To: Pamela Santos – Barker & Associates Limited
From: Cam Wallace – Barker & Associates Limited
Date: 12 December 2024
Re: Updated CPTED Review - Pūmanawa Downtown West

Figure 1 – Location of Key Changes to Level 00

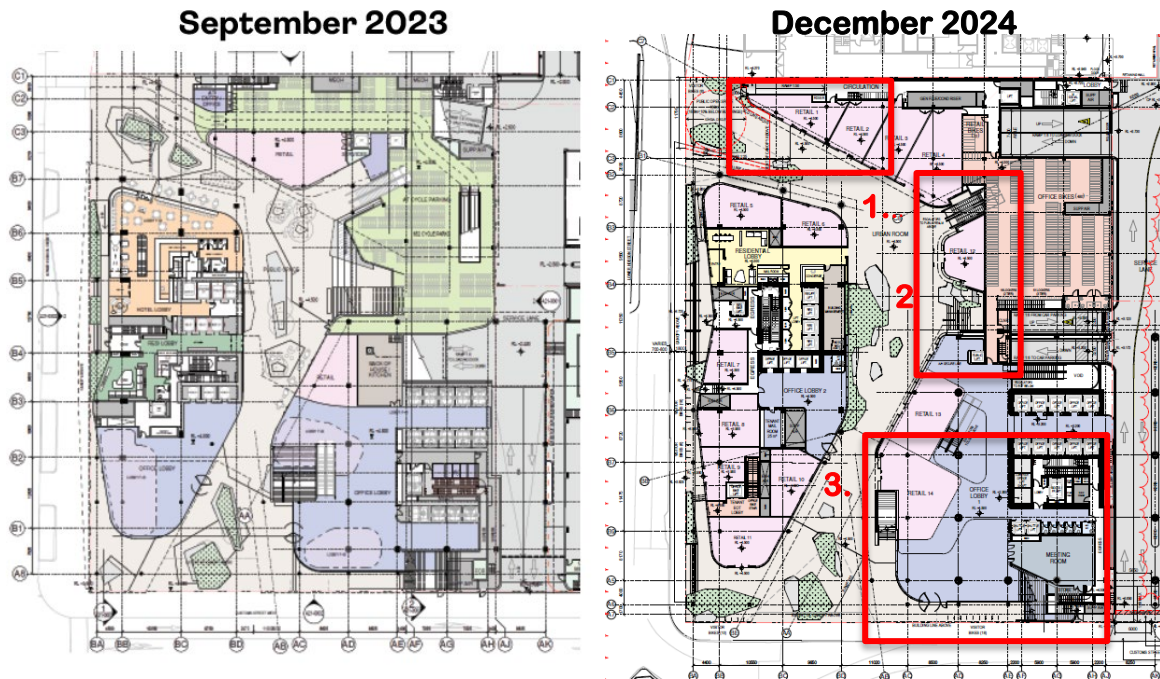
Key changes to the Level 00 Plan include:

1. Extension of ground floor retail spaces, removal of the AT Bike Store and reconfiguration of the main cyclist access point further to the west towards Lower Hobson Street in proximity to the MSocial rear access;
2. Shifting of the escalators further west and removal of the former public lift lobby. This lift lobby has now been shifted south adjacent to the main stairs leading from Level 00 to Level 01 and a reconfigured office lobby; and
3. Changes to the lobby in the south-east corner of the development adjacent to the existing service lane. This move includes reconfiguration of external stairs from Customs Street West to Level 01.

Figure 2 - Location of Key Changes to Level 01

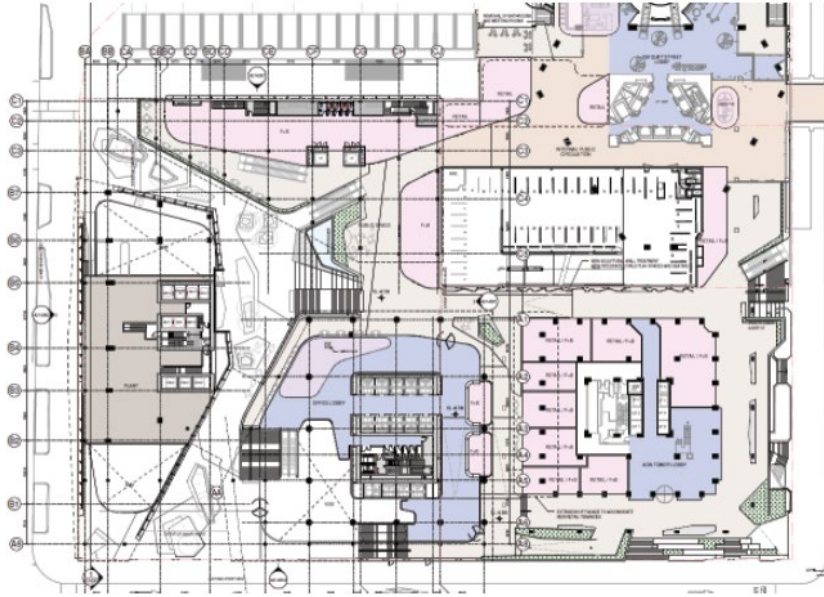
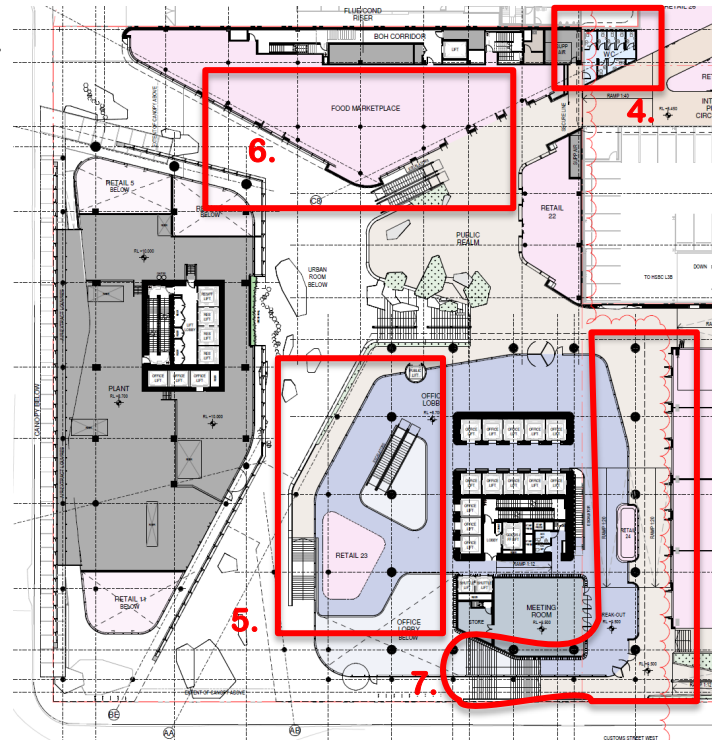
Key changes to the Level 01 Plan include:

4. Introduction of public toilets accessed off the northern east-west link and adjacent to a proposed food court / food market;
5. Reconfiguration of the office lobby and retail space (this is linked with matter #2 above);
6. Expansion of the retail space and removal of public balcony which extended west of the escalators (this is linked with matter #1 above); and
7. Reconfiguration of the external stairs from Customs Street West to Level 01 and a slight narrowing of the north-south pedestrian link (this is linked with matter #3 above).
